AGENDA
CITY OF LAKE WORTH BEACH
SPECIAL CITY COMMISSION MEETING #2 - DOKA APPEAL CONTINUATION
CITY HALL COMMISSION CHAMBER
TUESDAY, MAY 25, 2021 - 6:00 PM

Appeal by Alfred Malefatto, Esq. on behalf of Marlin Industrial Park Owners Association of PZB Project # 20-01400035 commonly referred to as "Umdasch/Doka," which included site plan, sustainable bonus and conditional use approvals to allow for the construction of a +/-47,000 square foot distribution facility and repair and maintenance uses within the Industrial Park of Commerce (I-POC) zoning district

PROJECT NAME: Umdasch/Doka, 2209 7th Avenue North, PZB 20-01400035
APPLICANT/OWNER: Lisa Reves of Saul, Ewing, Arnstein and Lehr/Umdasch Real Estate USA, Ltd.
APPLICANT'S ADDRESS: 515 North Flagler Drive, West Palm Beach, FL 33401
DATE OF HEARING: January 6, 2021
APPROVAL SOUGHT: Major Site Plan with Sustainable Bonus and Conditional Use to construct a +/- 47,000 square foot distribution facility and repair and maintenance uses at 2209 7th Avenue North.
PROPERTY LOCATION: 2209 7th Avenue North
PCN: 38-43-44-20-01-066-0010

RE: APPEAL BY AFFECTED PARTY MARLIN INDUSTRIAL PARK OWNERS’ ASSOCIATION INC.
PZB Project Number 20-01400035:

DRAWING NUMBER: A-0.1

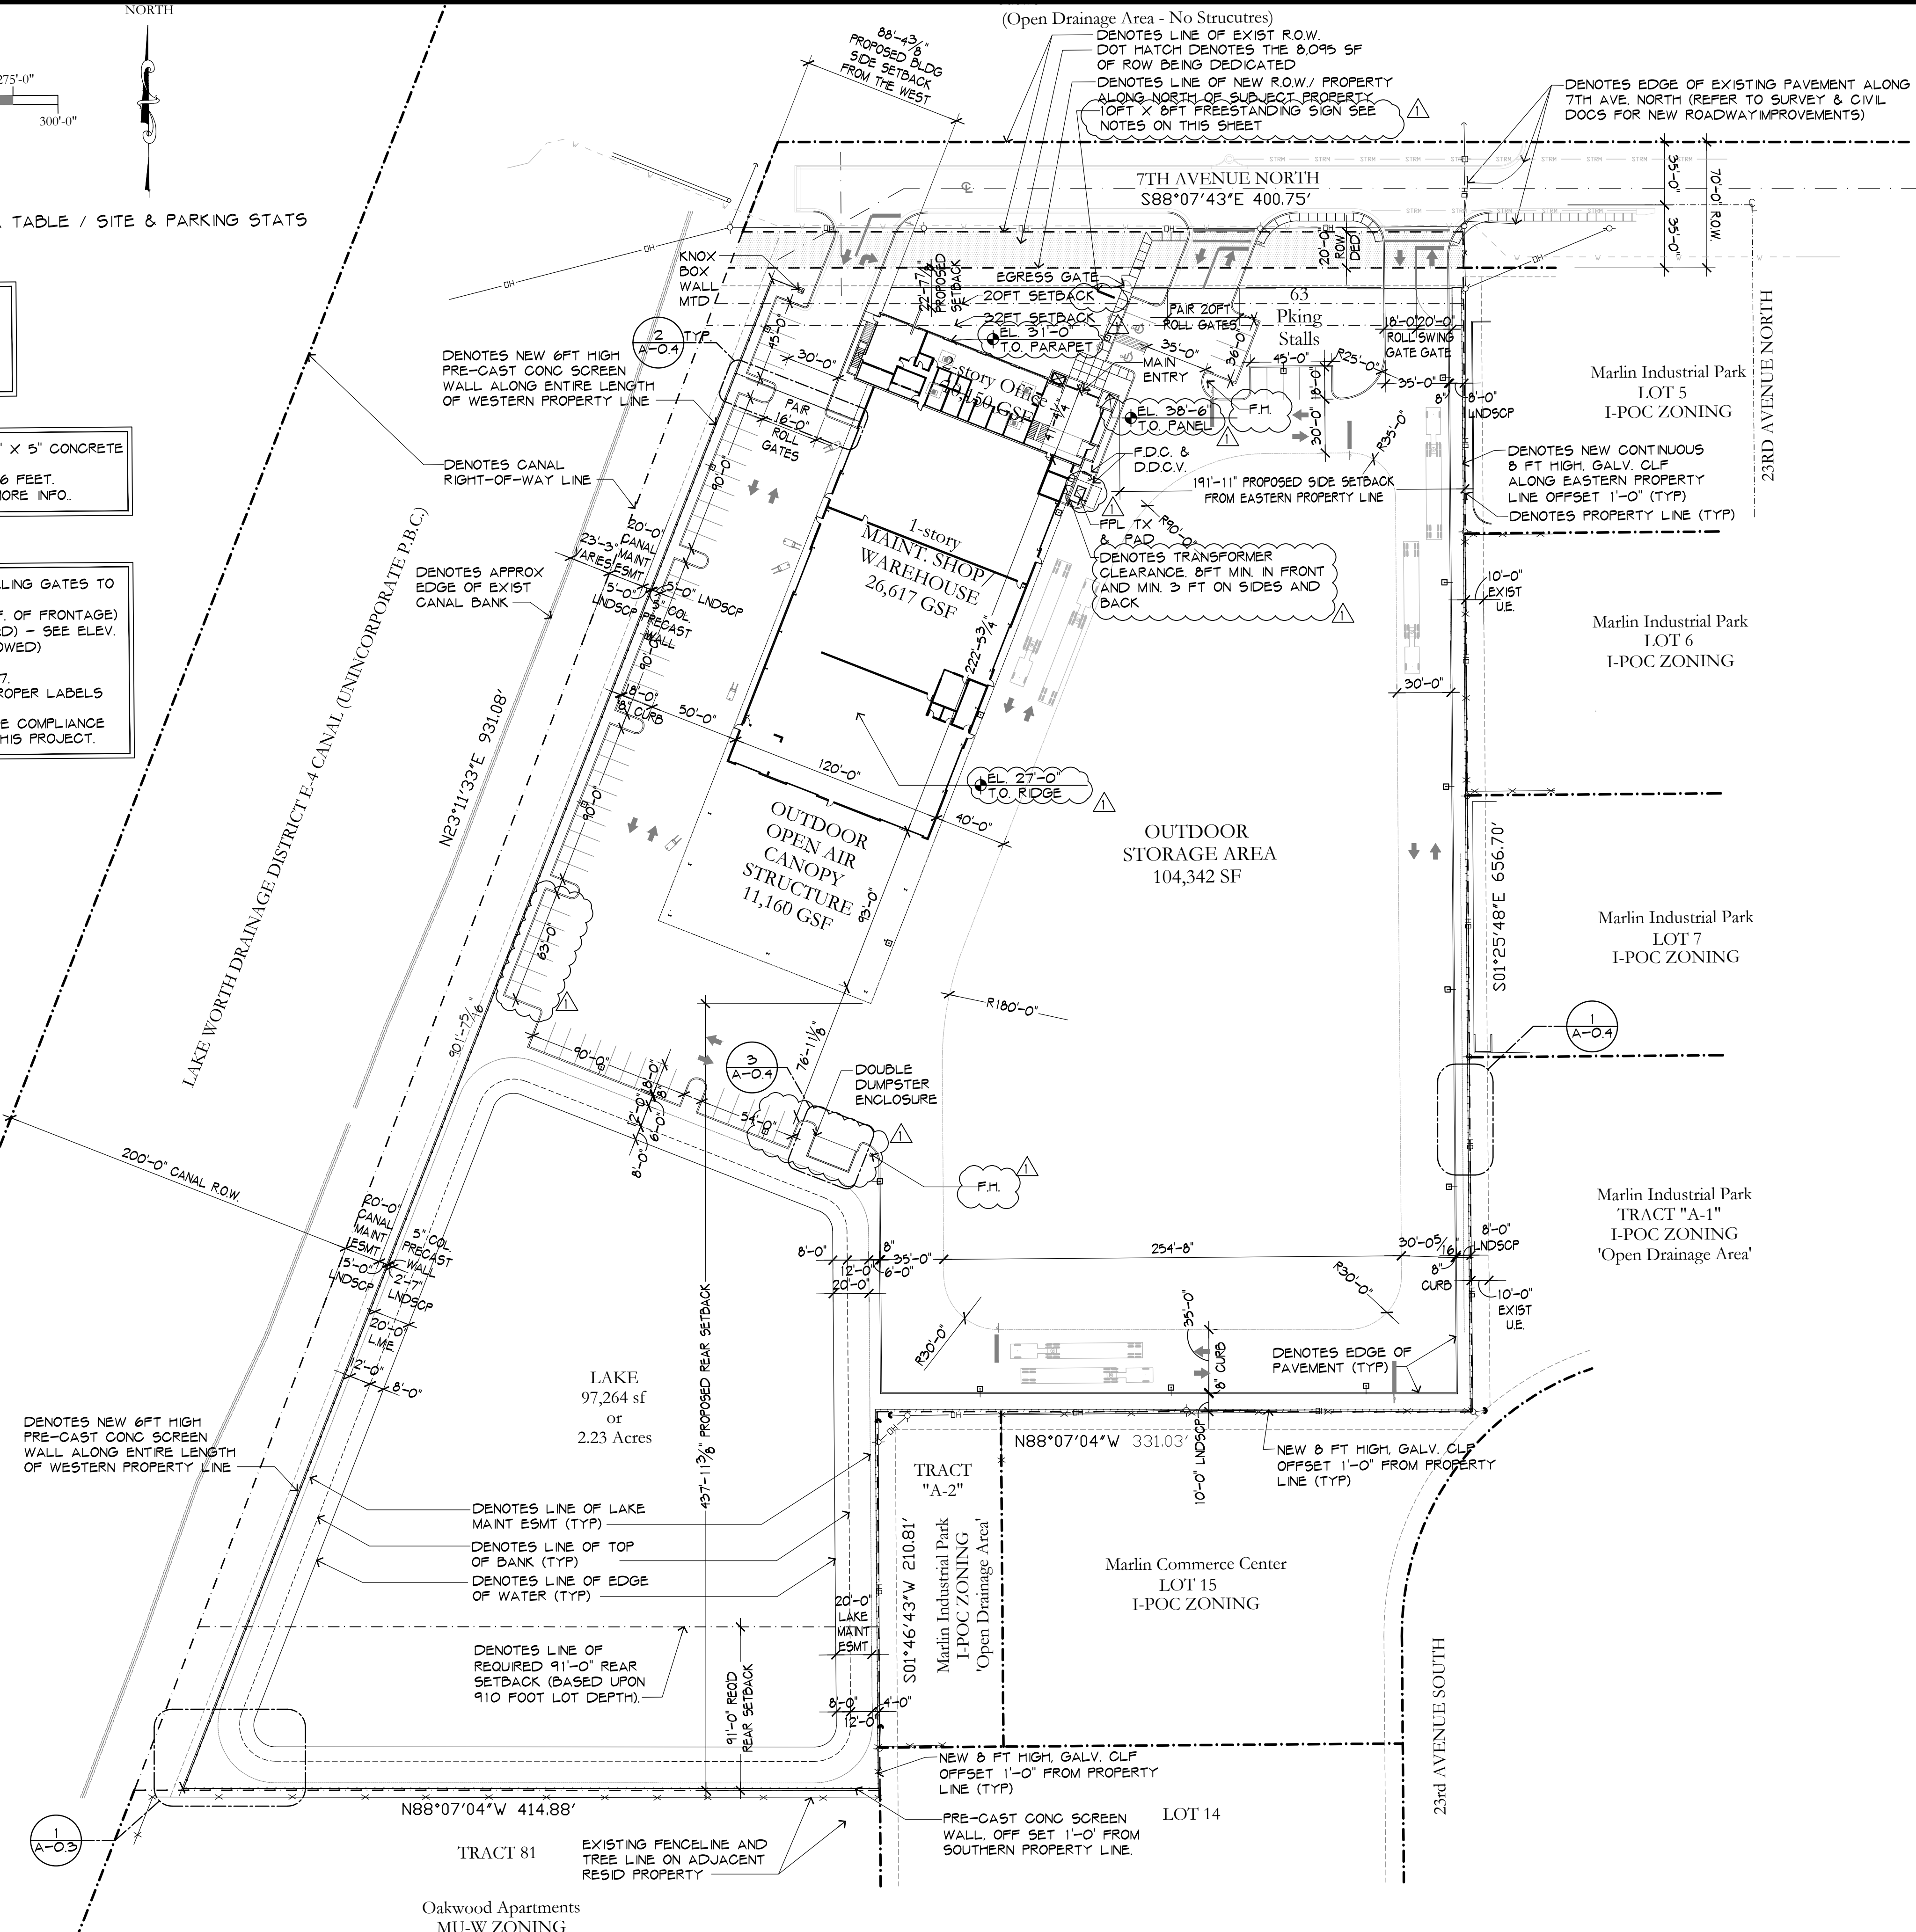
Staff- The Condition of Approval will require the chain link fence, as depicted on the site plan, be an opaque fence or wall 6-8 feet in height.
